RATE BASE AND CAPITAL EXPENDITURE

2-Staff-3

Figure 20 Age Distribution of In-Service Wood Distribution Poles

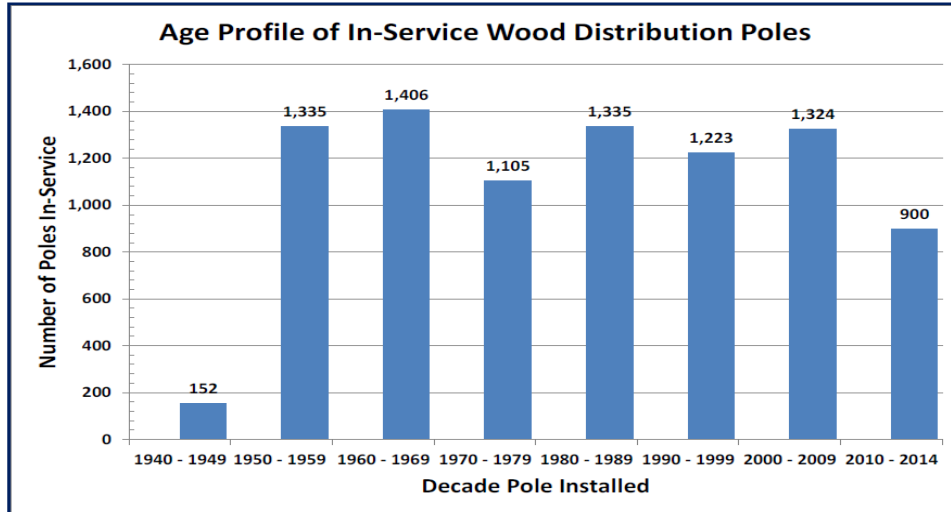
The application states, “As can be seen in the graph above, Halton Hills Hydro has 1400 poles exceeding their 50 year expected lifespan and an additional 1400 poles approaching end of life. Given this age profile, Halton Hills Hydro has implemented an accelerated pole replacement program targeting 275-280 distribution poles each year for the next ten years.”

For an asset class such as wood poles with a 50-year actuarial “Useful Life”, approximately 2% of HHHI’s 8,780 wood pole portfolio (or approximately 175 poles) would need to be replaced each year over the longer term. HHHI plans to replace 275 to 280 poles, or just over 3% of its pole portfolio, per annum.

- c) Is the accelerated pace of the HHHI pole replacement program described in the DSP based primarily upon assessed pole condition or upon replacing poles that have exceeded the actuarial “Useful Life” threshold?

- b) HHHI intends to replace 275-280 poles annually over the forecast period. At present HHHI has not identified the number of poles as it relates to pole condition that will be replaced each year. HHHI will focus on “defective” poles identified during pole testing and pole assets that have surpassed end of life.

- c) HHHI’s accelerated pole replacement program is a proactive measure that addresses pole condition assessments and risks involved with operating significantly aged assets that have surpassed their useful life.

Figure 21 Pole Condition

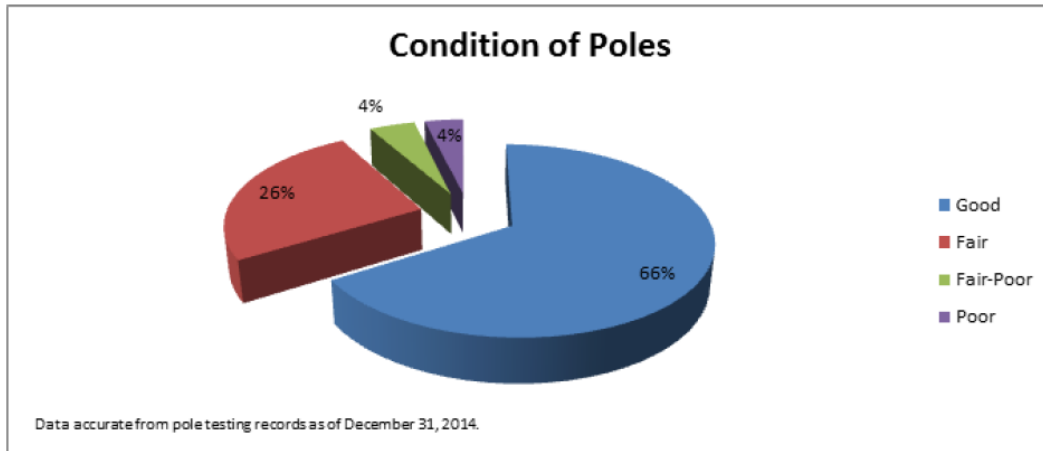
The application states, “As can be seen from the chart below, 34% of Halton Hills Hydro poles have some level of damage or wear.”

HHHI has identified that it intends to implement a pole replacement program with a capital cost of \$2 million per annum for the next 10 years. Under this plan a total of between 2,750 and 2,800 poles will be replaced over the next 10 years, representing 31% - 32% of HHHI’s pole portfolio. This number is nearly equal to the total number of poles assessed as being in “Fair” (26%), “Fair-Poor” (4%) and “Poor” condition (4%).

- d) Does HHHI consider “some level of damage or wear” to be an appropriate criterion to trigger pole replacement?
- e) How does HHHI determine which poles need to be replaced immediately? In other words, is there a separate category below “Poor” used to identify poles that require immediate replacement?

- d) No, HHHI conducts annual pole inspections and testing using a qualified inspection company. Their assessment of pole condition and identification of defective poles provide criteria for pole replacements.

- e) During annual testing a quantity of poles are normally identified as “defective” and to be replaced in the same year as the testing. HHHI uses these recommendations of the pole testing company and prepares work packages to effect the replacement of the identified poles.

Figure 38 Ranking Scheme for Prioritizing Cable Replacement / Rejuvenation Projects

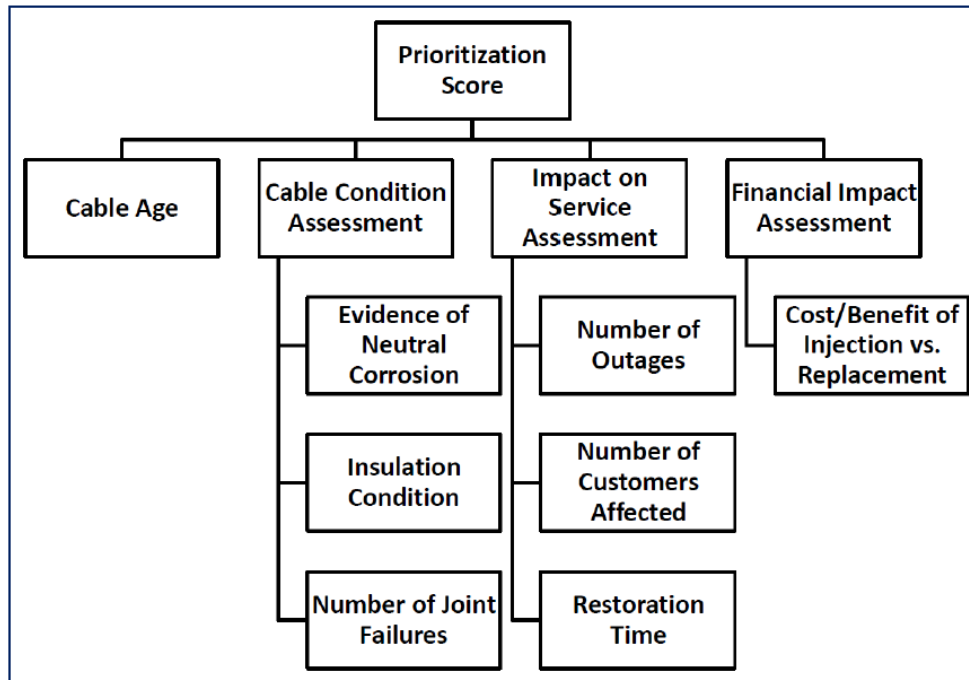
- a) How does HHHI determine that a particular underground cable requires or would benefit from injection treatment, prior to conducting the Financial Impact Assessment process step shown in Figure 38?
- b) Has HHHI developed a database to track underground cable failures by vintage, voltage, cable type or any other usefully indicative parameters, to help anticipate future cable failures, or to assist with planning preventive cable replacement or treatment projects?
- c) Please quantify the annual capital expenditure reductions achieved to date by adopting the Ranking Scheme shown in Figure 38.

- a) HHHI has only piloted cable rejuvenation technologies thus far. Cables on which rejuvenation was piloted were identified after having failed and are direct buried (not in duct) where replacement may have been a viable but costly option.
- b) HHHI has not developed a database to track underground cable failures.
- c) At this time the pilot project is still underway and therefore no final financial analysis can be performed at this time.
